ADDENDUM TO THE CONTRACT

**Bartlett Regional Hospital
MRI & CT Replacement
Contract No. BE23-042**

ADDENDUM NO.: THREE

DATE ADDENDUM ISSUED: August 11, 2022

Sheet Title
**FOUNDATION DRAINAGE
 PLAN**

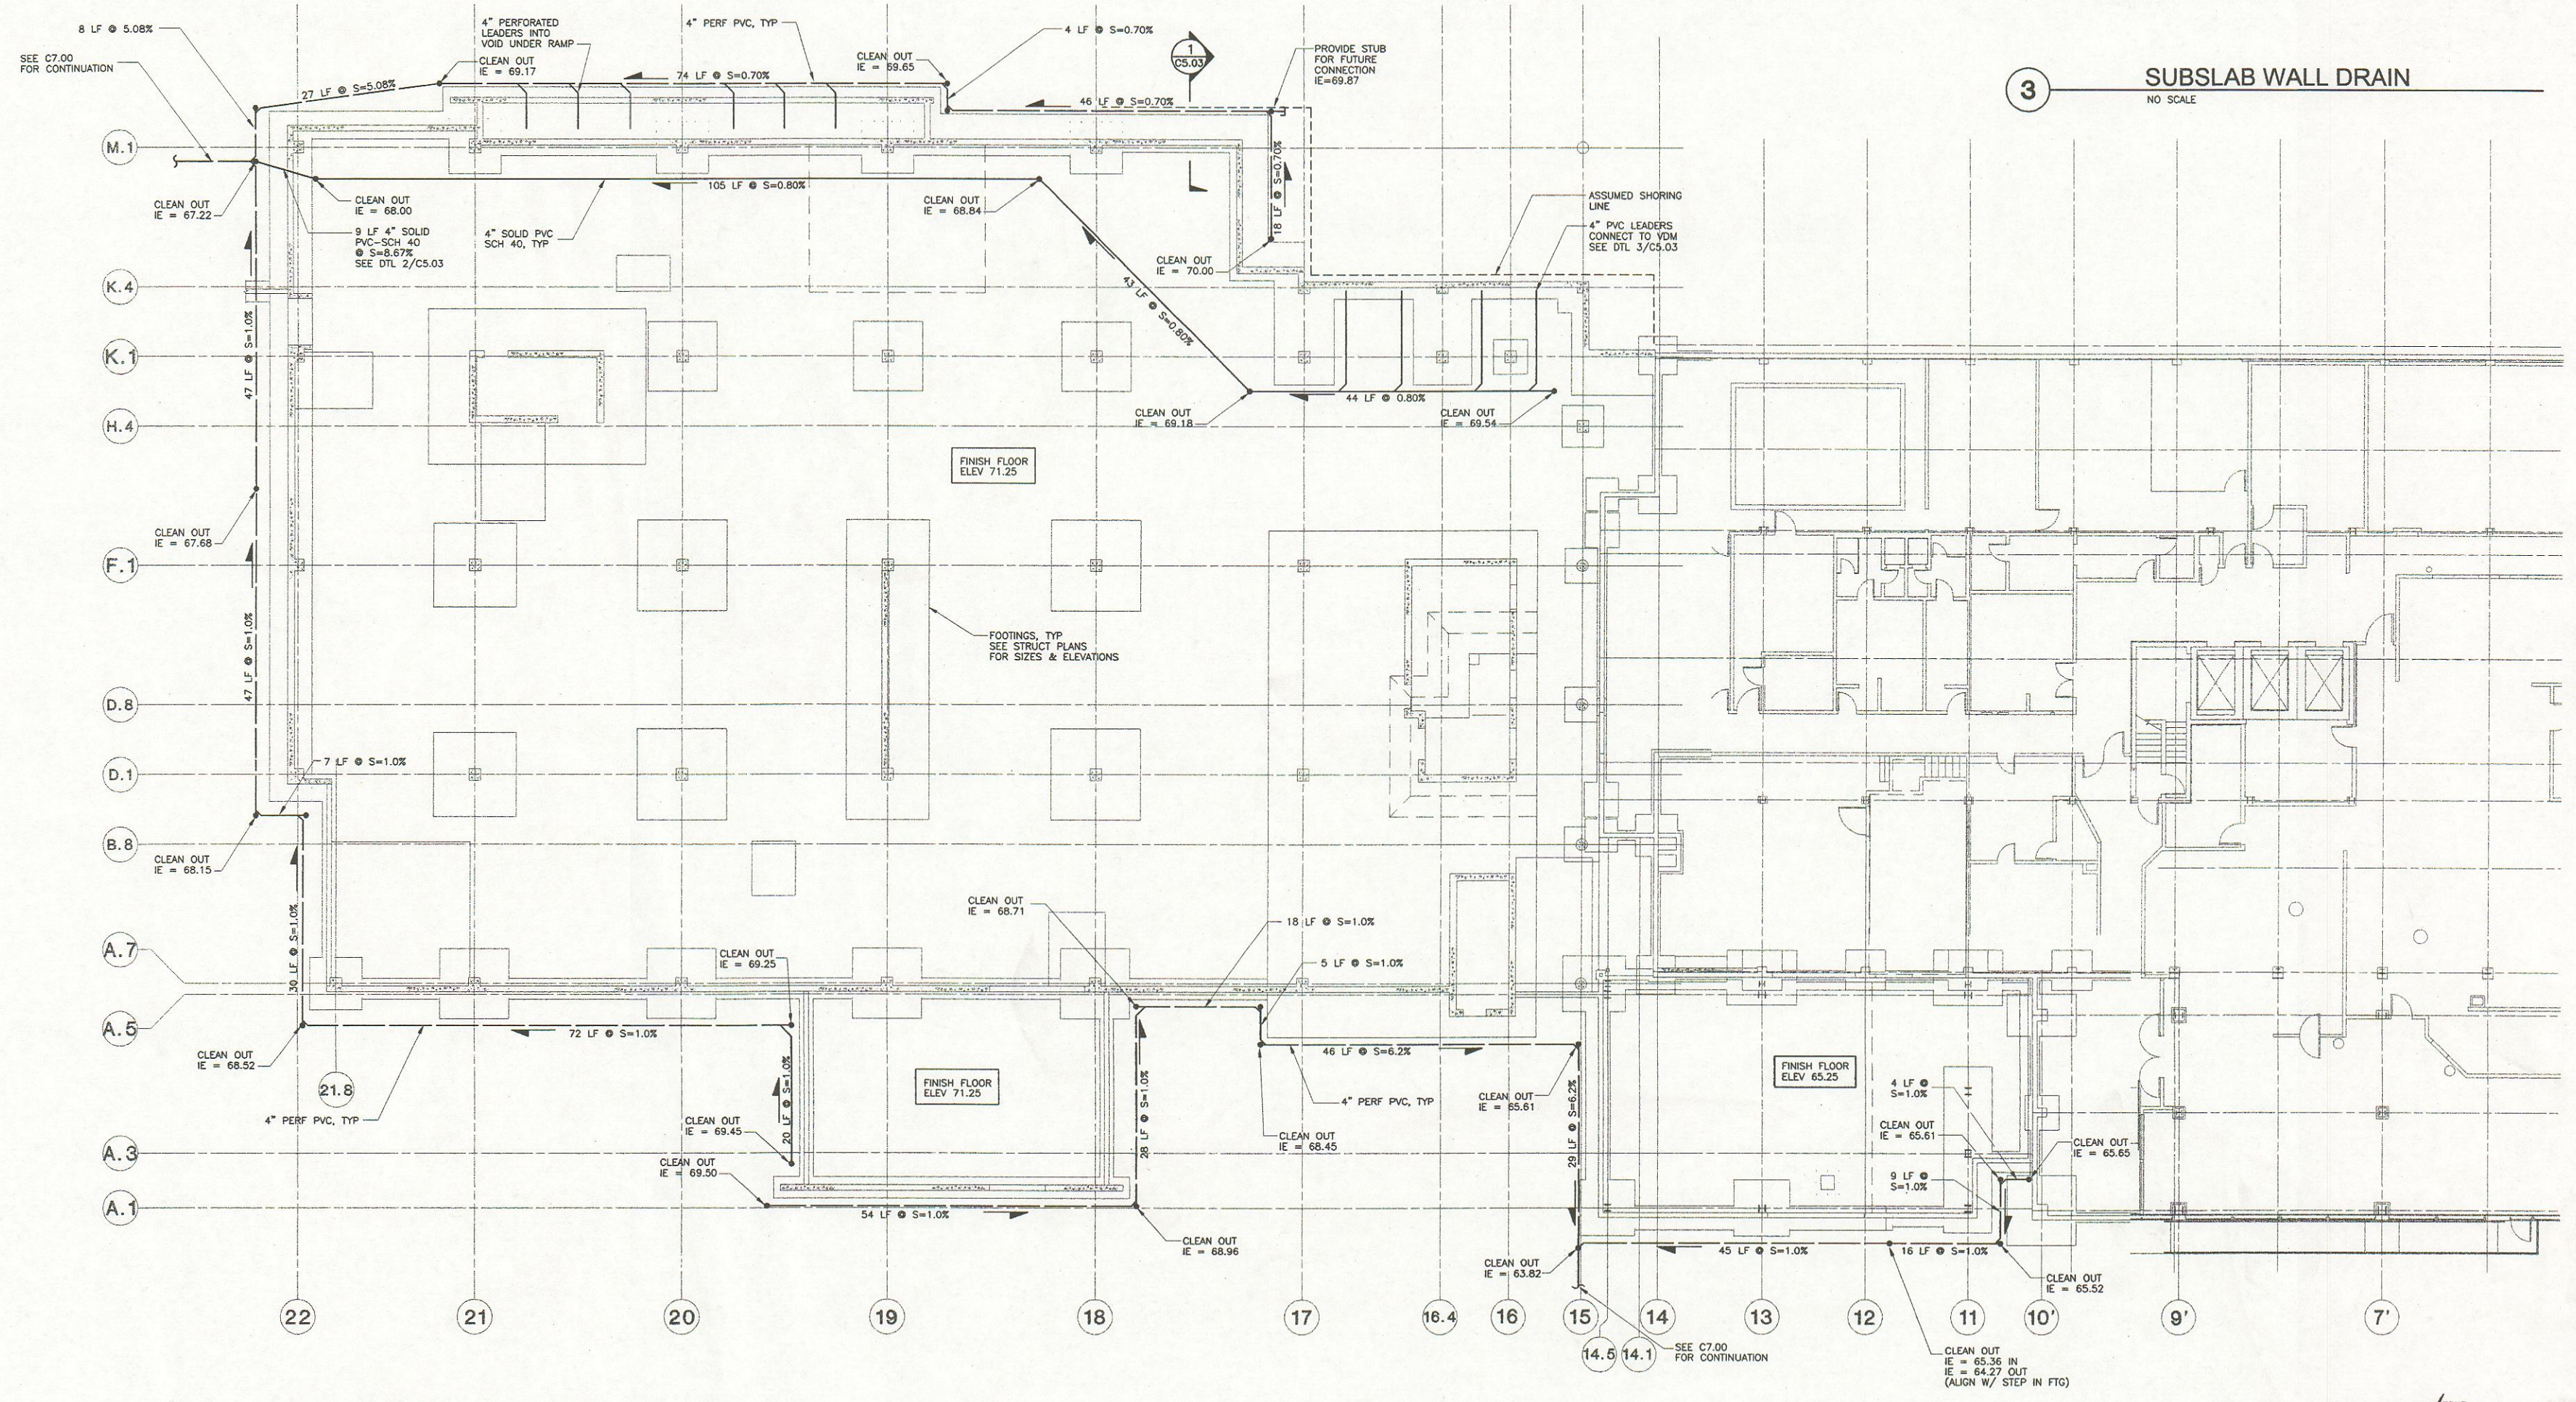
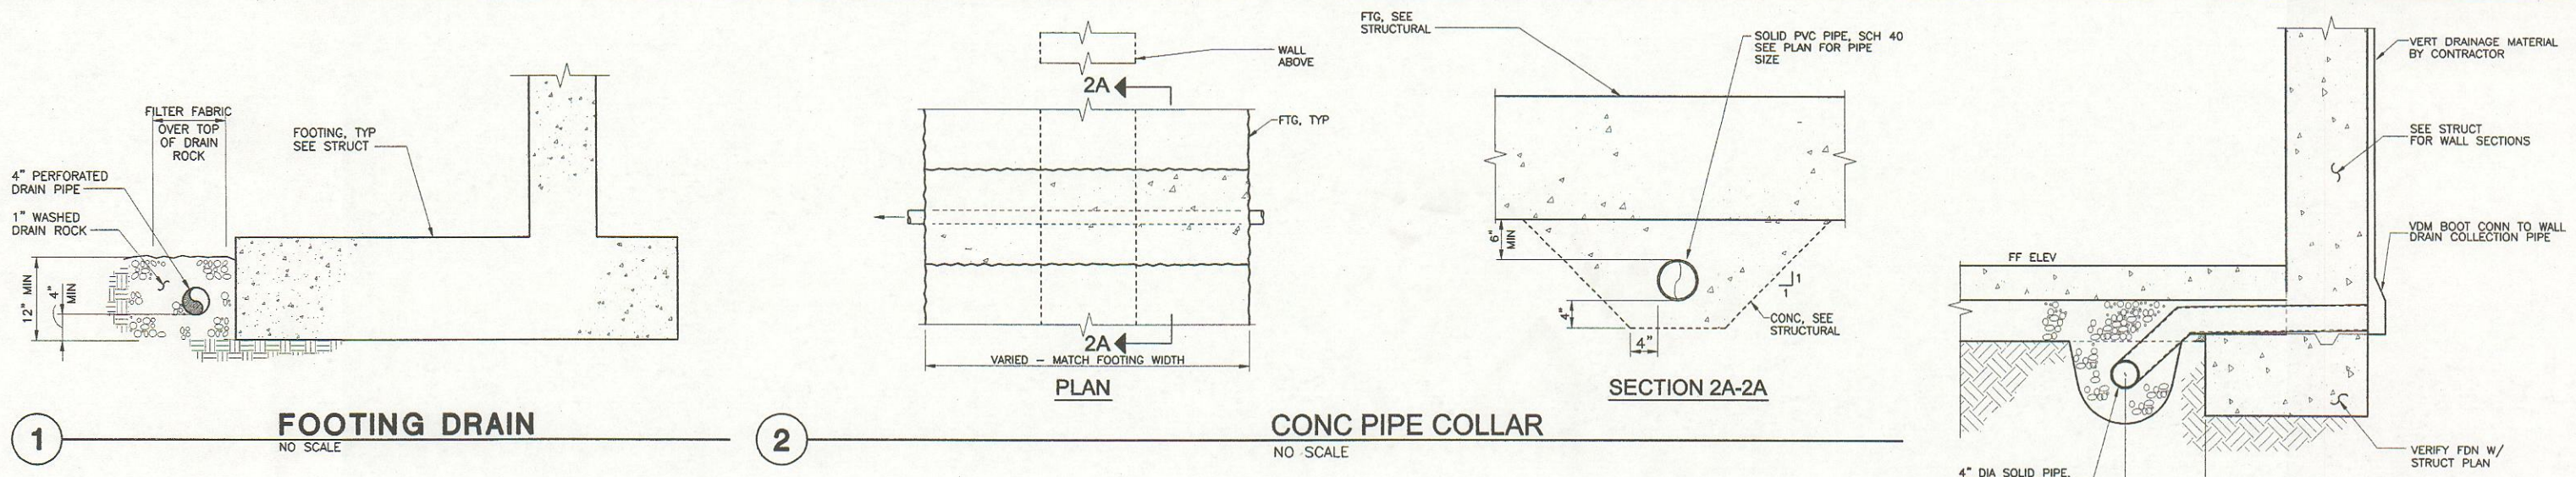
Question: *"Please provide record drawings and/or geotechnical report for area beneath new chiller pad. (C/S102)."*

Response: See attached related 2004 drawings (C1.00, C3.00, and C5.03) to aid in bidding purposes. Call (907) 586-1333 for underground utility locates and 811 Alaska Digline for underground ACS & GCI locates prior to any excavation activities. The contractor is responsible for locating, protecting and maintaining the utilities through the construction of the project. Any damage to the underground utilities during construction shall be paid for by the contractor and shall be considered incidental to the contract.
